**SUBJECT:** SALEM NUCLEAR GENERATING STATION, UNITS 1 AND 2 - STAFF ASSESSMENT OF INFORMATION PROVIDED PURSUANT TO TITLE 10 OF THE *CODE OF FEDERAL REGULATIONS* PART 50, SECTION 50.54(f), SEISMIC HAZARD REEVALUATIONS FOR RECOMMENDATION 2.1 OF THE NEAR-TERM TASK FORCE REVIEW OF INSIGHTS FROM THE FUKUSHIMA DAI-ICHI ACCIDENT (CAC NOS. MF3922 AND MF3923)

STAFF ASSESSMENT BY THE OFFICE OF NUCLEAR REACTOR REGULATION

RELATED TO SEISMIC HAZARD AND SCREENING REPORT

SALEM NUCLEAR GENERATING STATION, UNITS 1 AND 2

Figure 3.3-1 Plot of the Staff's and Licensee's Base Case Shear-Wave Velocity Profiles for the Salem site

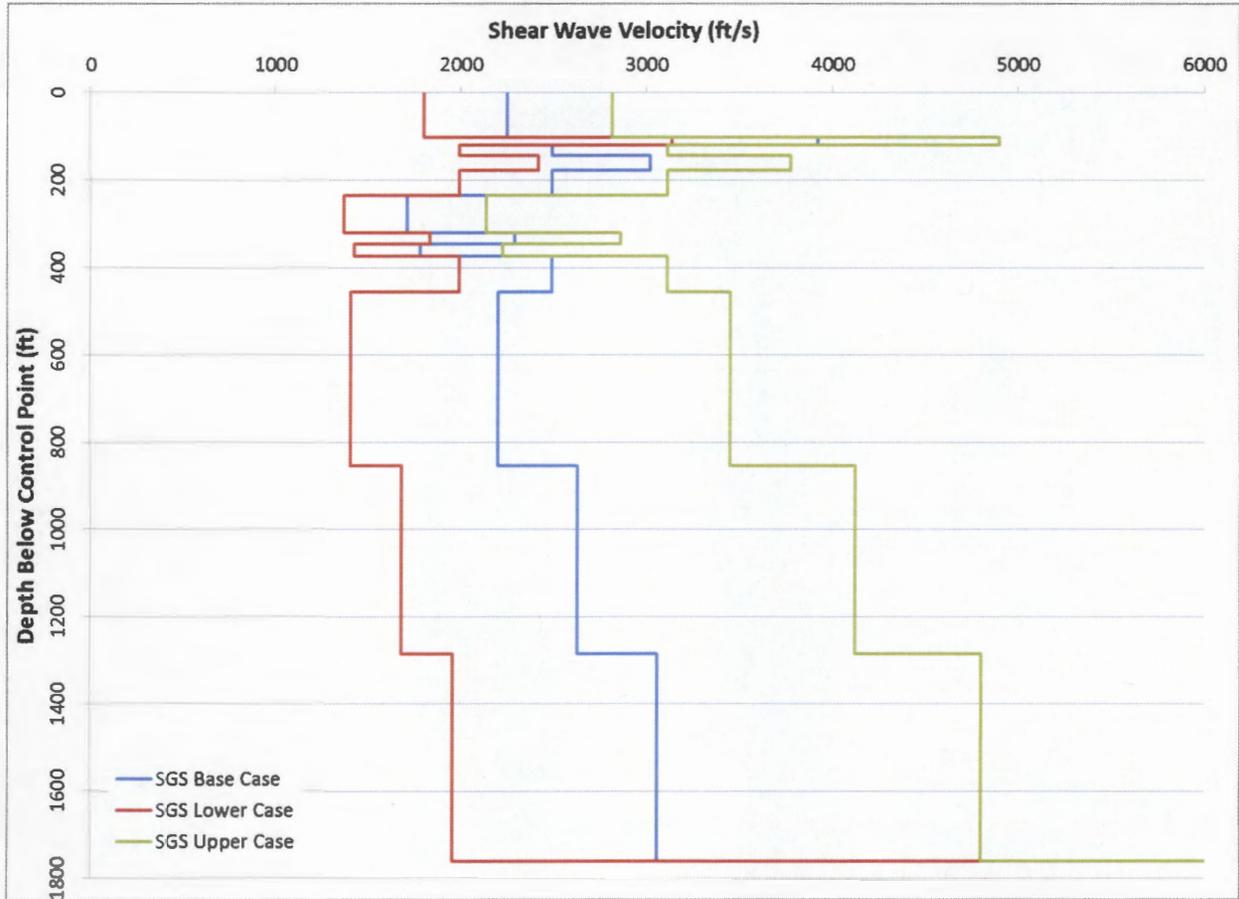
To capture the uncertainty in the shear wave velocity beneath the site, the licensee developed three base case shear-wave velocity profiles for the Salem site. The licensee used a natural log standard deviation of 0.20 to calculate the lower and upper base case shear-wave velocity profiles to a depth of approximately 444 ft. (135 m) and a natural log standard deviation of 0.35 to calculate the lower and upper base case shear-wave velocity profiles from 444 ft. (135 m) depth to bedrock at 1,800 ft. (548 m). Table 2-2 and Figure 2-1 of the SHSR provide the licensee's shear-wave velocity profile for each of the three base cases. Figure 3.3-1 of this assessment shows the licensee's three shear-wave velocity base case profiles.

Because the site is well characterized and the velocities are reported in the PSEG ESPA (PSEG, 2013), the NRC staff used the same three base case shear-wave velocity profiles developed by the licensee for the Salem site. To capture the uncertainty in the depth to base rock, the NRC staff used a value of  $\pm 90$  ft. [ $\pm 27$  m], which is less than the  $\pm 505$  ft. ( $\pm 153$  m) depth to base rock randomization used by the licensee. Figure 3.3-1 of this assessment illustrates the velocity profiles the NRC staff used in its confirmatory analysis.

Figure 3.3-2 Plot Comparing the Staff's and the License's Median Amplification Functions and Uncertainties for two input loading levels for the Salem site

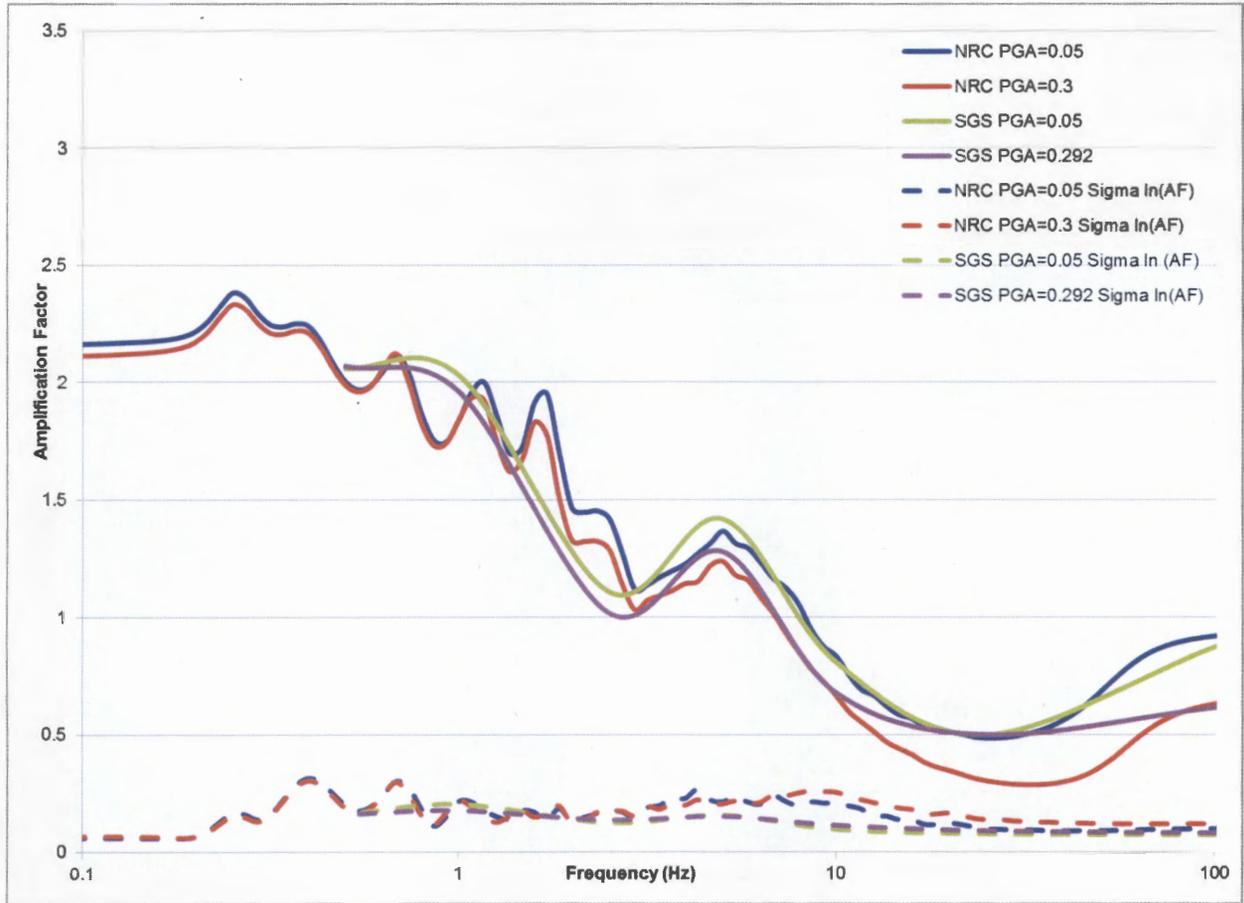
Figure 3.3-2 of this assessment shows a comparison of the NRC staff's and licensee's median site amplification factors and uncertainties ( $\pm 1$  standard deviation) for 2 of the 11 input loading levels. The NRC staff conducted sensitivity tests to evaluate the licensee's characterization of the site and its use of (1) multiple base case velocity profiles, (2) kappa values, and (3) depth to bedrock randomization value. Of these three factors, the NRC staff used a smaller depth to bedrock randomization value (5 percent), compared to the larger value used by the licensee (30 percent). However, as seen in Figure 3.3-2 of this assessment, both the NRC staff and licensee's site amplification factors are similar, such that the difference in the depth to bedrock randomization value does not produce large difference in site amplification factors at the Salem site. Therefore, based on these sensitivity analyses, the NRC staff concludes that the licensee's evaluation for Salem site adequately captures the site amplification occurring as a result of bedrock ground motions travelling upward through the soil/rock column to the control point elevation.

Figure 3.3-3 Plot Comparing the Staff's and the Licensee's Mean Control Point Hazard Curves at a Variety of Frequencies for the Salem site

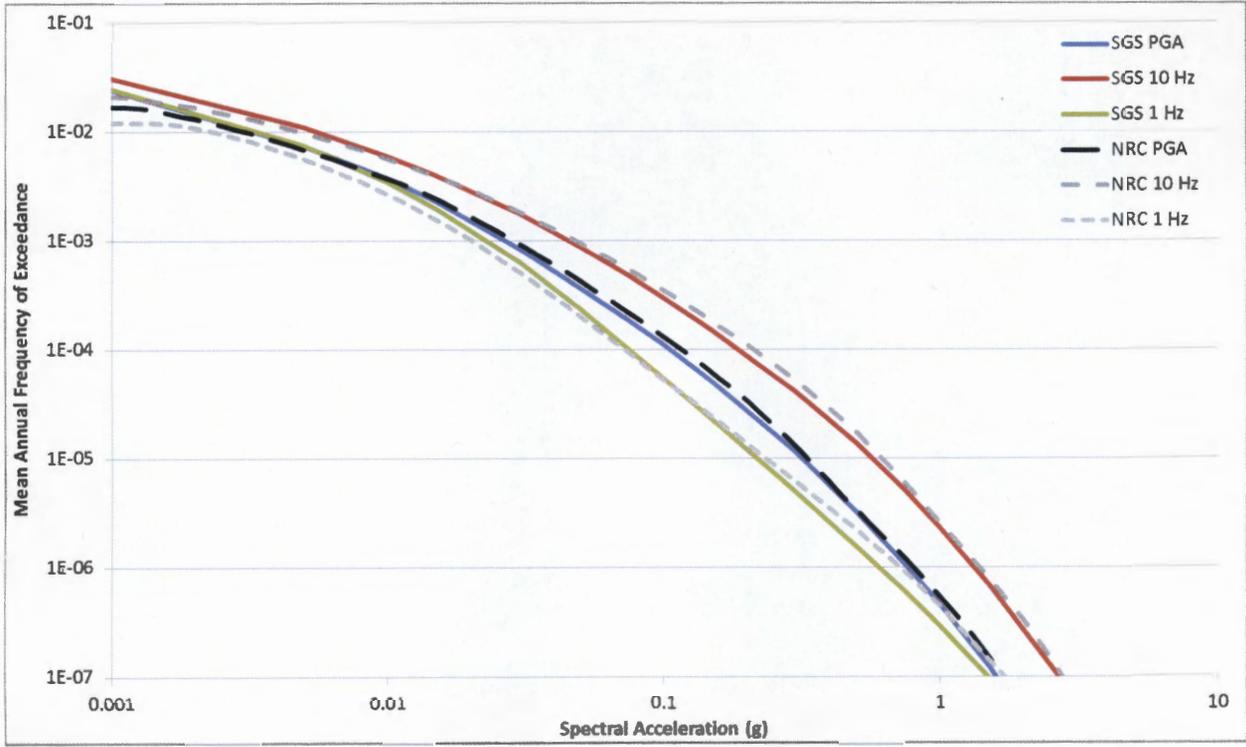
Figure 3.3-3 of this assessment provides the licensee's and NRC staff's control point seismic hazard curves for the Salem site. As shown in Figure 3.3-3, the slight differences in the licensee's and NRC staff's site response analyses do not have a large impact on the control point seismic hazard curves or the resulting GMRS, as discussed below. Appendix B of the SPID provides guidance for performing site response analyses, including capturing the uncertainty for sites with less subsurface data; however, the guidance is neither prescriptive nor comprehensive. As such, various approaches in performing site response analyses, including the modeling of uncertainty, are acceptable for the response to the 50.54(f) letter.

Figure 3.4-1 Comparison of the Staff's GMRS, Licensee's GMRS, Salem site SSE, and the IHS for the Salem site.

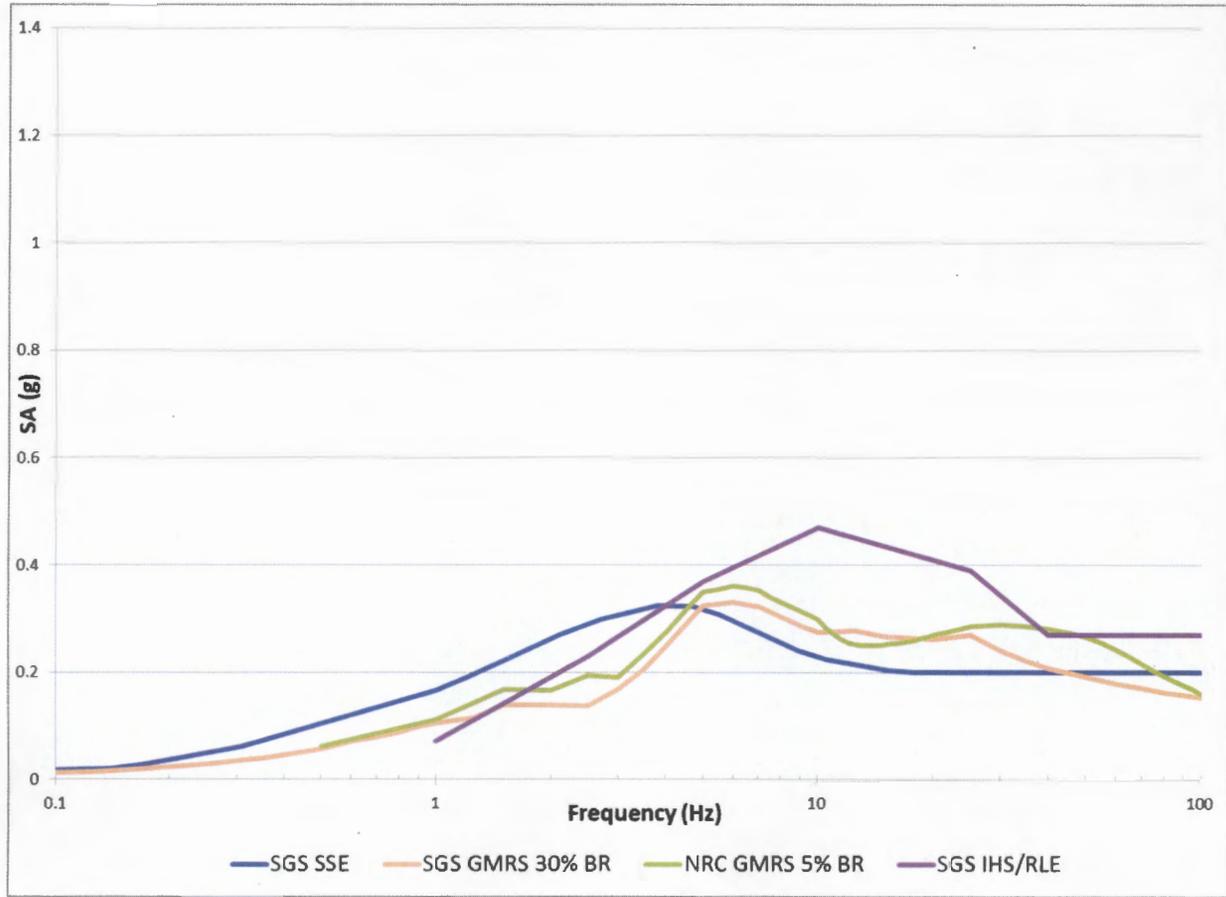
staff assessment, respectively. Figure 3.4-1 of this assessment shows a comparison of the GMRS determined by the licensee to that determined by the NRC staff.

As shown in Figure 3.4-1, the licensee's GMRS shape is generally similar to that calculated by the NRC staff at frequencies less than 10 Hz. However, NRC staff's confirmatory GMRS is somewhat higher than the licensee's at frequencies above 10 Hz. As described above in Section 3.3, the NRC staff concludes that these minor differences over the higher frequency range are primarily due to the differences in the site response analyses performed by the licensee and NRC staff.

The NRC staff confirms that the licensee used the present-day guidance and methodology outlined in RG 1.208 and the SPID to calculate the horizontal GMRS, as requested in the 50.54(f) letter. The NRC staff performed both a PSHA and site response confirmatory analysis and achieved results consistent with the licensee's horizontal GMRS. As such, the NRC staff concludes that the GMRS determined by the licensee adequately characterizes the reevaluated hazard for the Salem site. Therefore, this GMRS is suitable for use in subsequent evaluations and confirmations, as needed, for the response to the 50.54(f) letter.
